APPLICATION NO: 21/02456/FUL

DESCRIPTION: Development works to create new sports facilities including new hockey field and playing field together with a new pavilion. Associated hard and soft landscaping works and provision of new vehicular access.

LOCATION: School, Kitebrook House, Little Compton, Oxfordshire GL56 ORP

View to the east

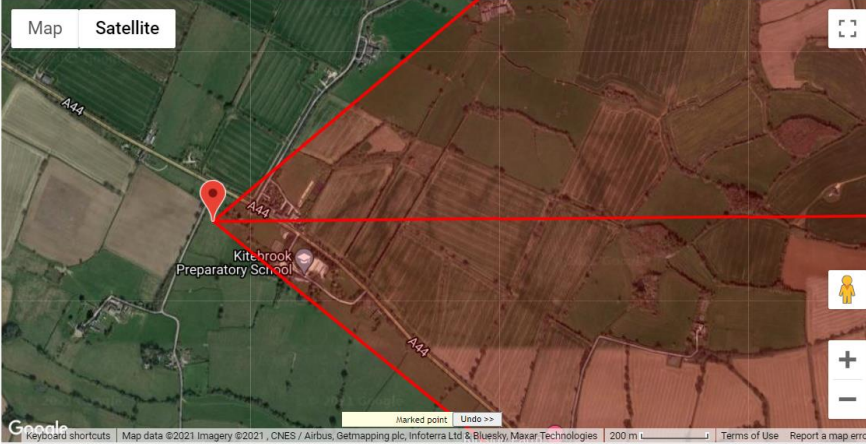
The information presented below uses visual panorama software from the Ulrich Deuschle website (https://udeuschle.de/panoramas/makepanoramas_en.htm). This indicates that the floodlights, could, in theory, be seen up to approximately 14km away to the west or east.
